HISTORIC AND DESIGN REVIEW COMMISSION

July 19, 2023

HDRC CASE NO: 2023-243
ADDRESS: 411 E EVERGREEN
LEGAL DESCRIPTION: NCB 396 BLK 29 LOT 9 & W 14 FT OF 10
ZONING: R-6, H
CITY COUNCIL DIST.: 1
DISTRICT: Tobin Hill Historic District
APPLICANT: GLADYS AYARZAGOITIA/GMAM
OWNER: GLADYS AYARZAGOITIA/GMAM
TYPE OF WORK: Fenestration modifications
APPLICATION RECEIVED: June 20, 2023
60-DAY REVIEW: August 19, 2023
CASE MANAGER: Claudia Espinosa

WINDOW SCHEDULE - MAIN FLOOR

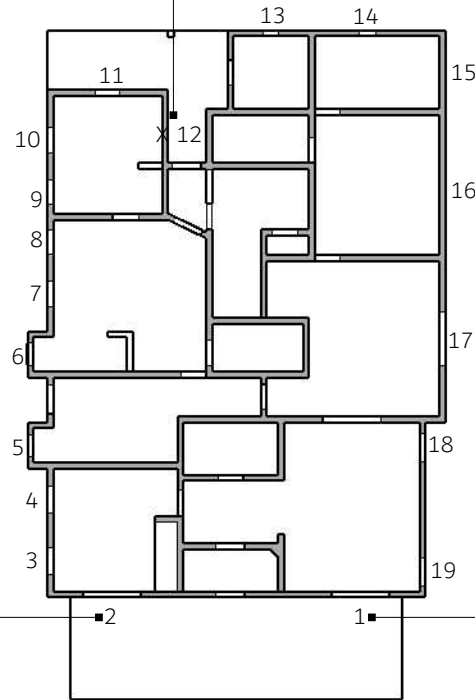
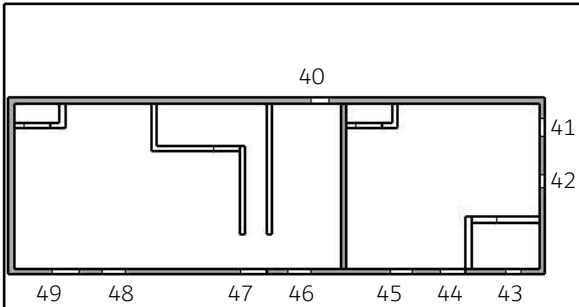
- b. WINDOW INFILL (NORTH ELEVATION) – The applicant is requesting to infill the ganged window openings, numbers 12 and 16, on the first story of the north elevation of the rear addition. Windows 12 and 16 are one-over-one sashed wood windows and the applicant has proposed to salvage the existing windows for installation on the front facade. The Guidelines for Exterior Maintenance and Alterations 6.A.i recommend that historic window openings be preserved. These windows are of traditional size and are located on the non-original rear addition. Staff finds the request for window infill appropriate provided that the material used to infill the openings matches the existing siding in materials, profile, and dimension.

- c. WINDOW INSTALLATION (FRONT FACADE) – The applicant is requesting to install the two cased one-over-one sashed wood windows that were removed from window openings number 12 and 16 on the front façade, in window openings 1 and 2. The Guidelines for Exterior Maintenance and Alterations 6.A.i recommend that historic window openings be preserved. The installation of the salvaged windows from openings 12 and 16 will require modifications to the size of the original front façade window openings. Staff finds the window installation to be appropriate provided that windows are installed to fit the existing openings in size, profile, and dimension. Staff finds modifications to the size of the existing window openings to be inappropriate. Staff finds that the applicant should source salvaged wood windows that do not alter the existing opening size, profile, and dimension and that the windows removed from the rear elevation be stored on-site for future use.

Item 1, staff recommends approval of the infill of the two ganged windows on the rear elevation based on finding b with the stipulation that the removed windows are salvaged and stored on site for future use.

Item 2, staff does not recommend approval of the reuse of the salvaged windows from the rear addition on the front façade, based on finding c. Staff recommends that a salvaged or new window that fits the existing openings be used instead. Staff does not recommend that the existing openings be modified.

REAR FACING - VIEW 1 WITH NOTES

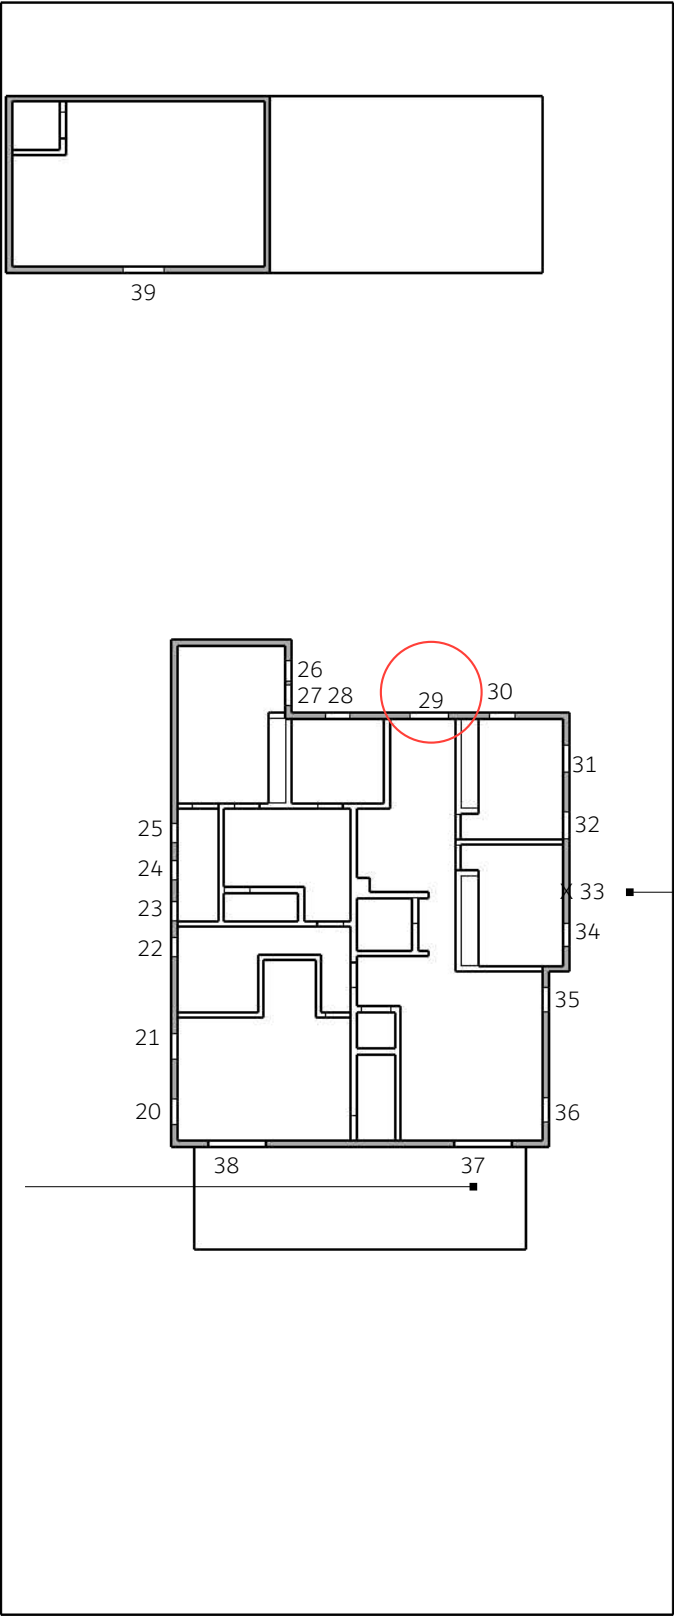
- d. WINDOW INFILL(EAST ELEVATION) – The applicant is requesting to infill window opening number 33 on the second story of the east elevation. Window number 33 is a one-over-one sashed wood window. The applicant has proposed to salvage and re-install the window in opening number 29 on the rear (north) elevation. The Guidelines for Exterior Maintenance and Alterations 6.A.i recommend that historic window openings be preserved. Staff finds the infill of window opening number 33 to be inappropriate and inconsistent with the Guidelines. Staff finds that the installation of a sashed wood window in opening 29 would be eligible for administrative approval.

Item 3, staff does not recommend approval of the infill of one window on the east elevation based on finding d. The existing window and the window opening should be retained. The installation of a sashed wood window in opening number 29 would be eligible for administrative approval.
